DDS- Planning & Zoning: Plan Review Application

1390 PARK ST
BUILDING
ALTERATIONS
1390 PARK ST.
HARTFORD, CT 06106

From: Paul Ashworth
Sent: Wednesday, June 29, 2022 11:45 AM
To: Natalie Sweeney
Cc: Hartford Planning Division; Hermann Cartes-Barrios
Subject: RE: 1390 Park St - Site Plan Application - ADMIN-2022-2943 & COMM-2022-0633
Attachments: 1390Park_PublicNoticeInstructions_for07262022.pdf; 1390Park_abutterslist_150feet.pdf; 1390park_PublicHearingNotice_for07262022.docx

I was able to take a look at the site plan amendment to 1390 Park St. Please respond to each of the comments listed below:

1 PROPOSED SITE PLAN & ZONING INFORMATION

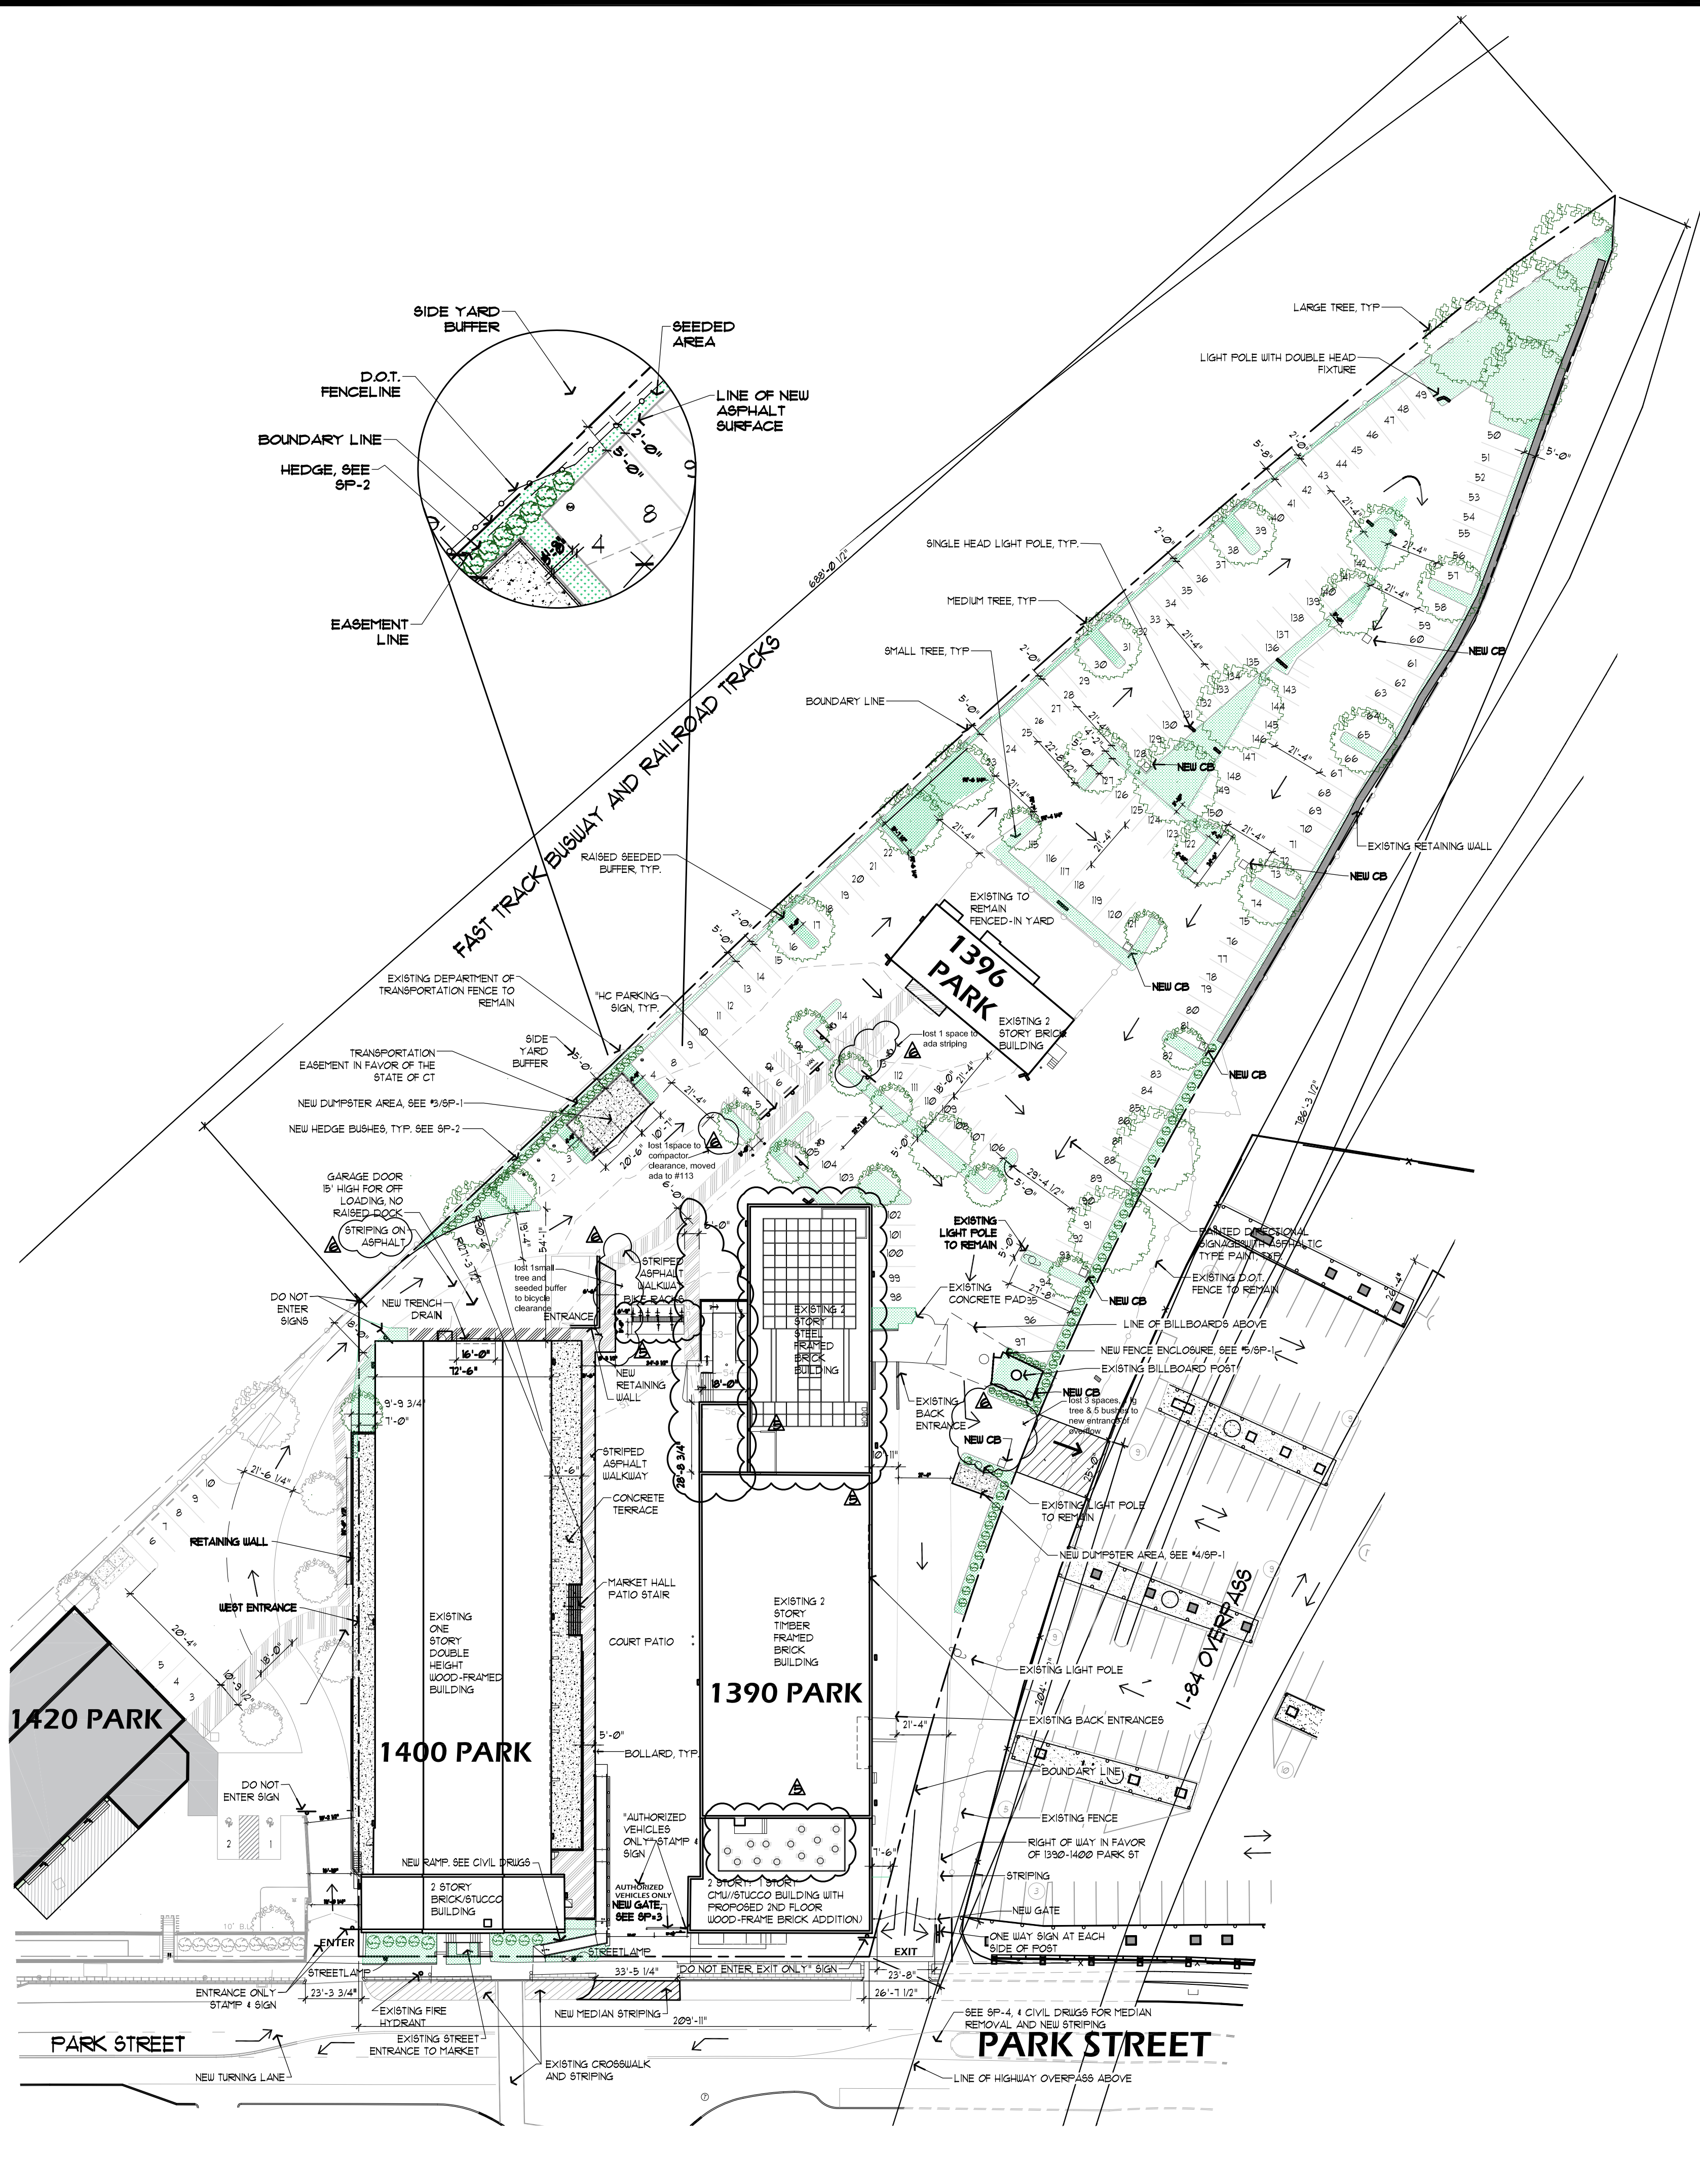
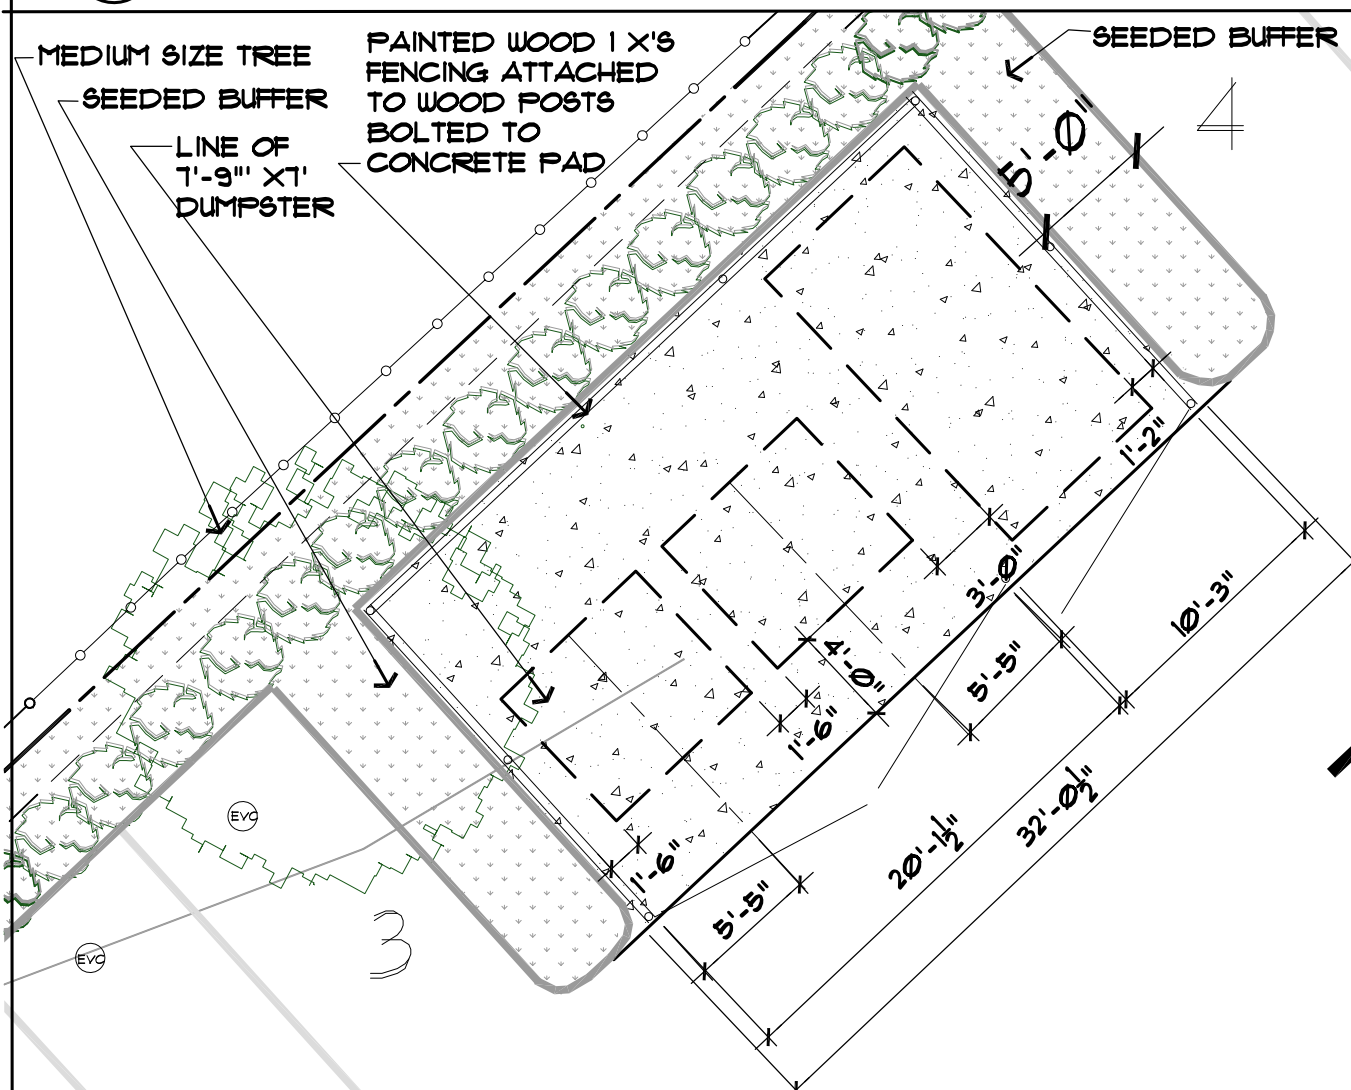
3. Has the zoning table been updated with the increase in building coverage?
There is no change to building coverage, new addition increased coverage from 27% to 27.25% so left it at 27% on matrix. Landscaping legend and parking have been updated on A-2 and A-3.

2 TYP. BIKE RACK DETAIL
SCALE: N.T.S.

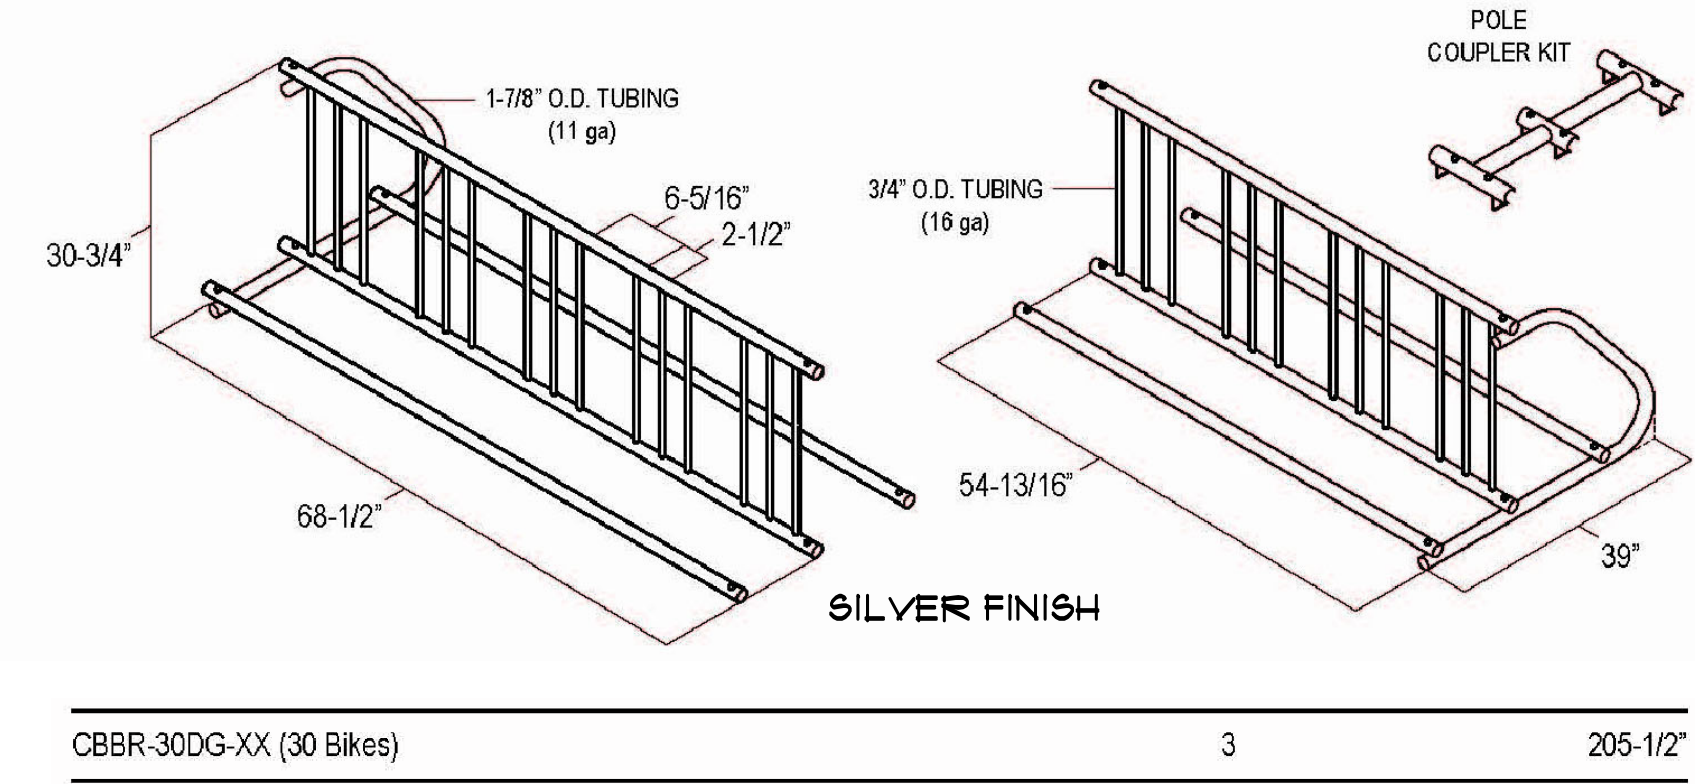
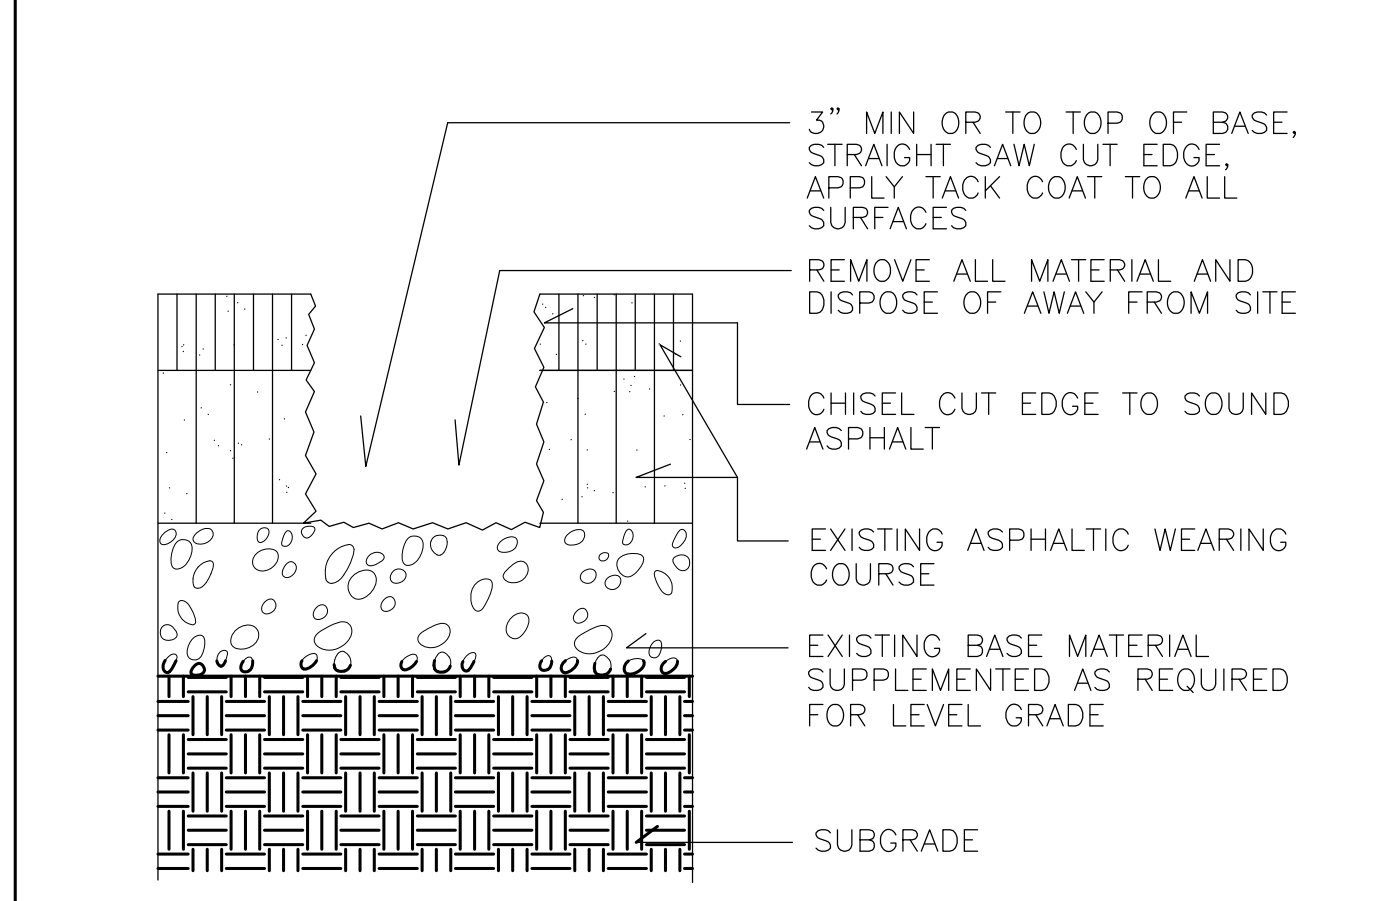
1. Please show a bike rack detail confirming design consistent w/ section 7.3.3.
Bike rack for multiple bikes and as per reg. 7.3.3 shown on A-3.
2. Just northwest of the new bike rack a comment has been removed calling out a "Painted, Slotted mountable curb." A landscape island is also missing however a tree is still shown that location. Please describe the changes made here and verify that the siting table is up to date (total ISR should be increased). **Asphalt curb was removed and striped instead. One ada space was relocated to allow better clearance towards trash compactor. One space removed to allow for relocated ada striping. 3 spaces, 5 bushes and 1 large tree removed to create drive to spillover parking under DOT overpass. One small tree and buffer removed to allow for clearance around bike rack. One small tree removed at north east corner of building to allow for walkway. See A-1, A-2, A-3 for notes and revisions clouds. Changes did not affect Total ISR, the green buffer by walk and at drive increased ISR by .05%, not enough to round up 90%.**
